Piper Aircraft Corporation

SERVICE *No. 811A* BULLETIN

(Service Bulletin No. 811A supersedes and voids Service Bulletin No. 698A, dated August 17, 1982 and Service Bulletin No. 811, dated January 8, 1986)

Ammeter Replacement

SKETCH "A"

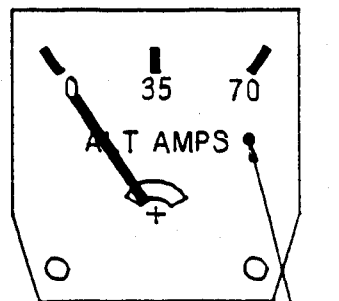
PURPOSE: Engineering tests have determined that a number of ammeter gauges shipped in support of Service Bulletin No. 811 were not correctly calibrated. Correctly calibrated gauges may be identified by the presence of a white dot located on the righthand side of the ammeter face, immediately following the word "AMPS". See Sketch "A" attached. Incorrect ammeter indications could lead to inadvertent overcharging and/or depletion of the aircraft's battery with subsequent loss of battery electrical power.

1. All aircraft which have complied with Service Bulletin No. 811 must inspect for the presence of a white dot on the righthand side of the ammeter face. See Sketch "A" attached.
2. If white dot is not present, the ammeter gauge, only, must be replaced with a correctly calibrated gauge.
3. Using applicable instructions for the Ammeter Replacement Kit, Piper Part Number 765-186, replace the newly installed ammeter only, with Ammeter, Piper Part Number 763-053.

MATERIAL REQUIRED: If required by inspection, one (1) each Ammeter Gauge, Piper Part Number 763-053, per affected aircraft.
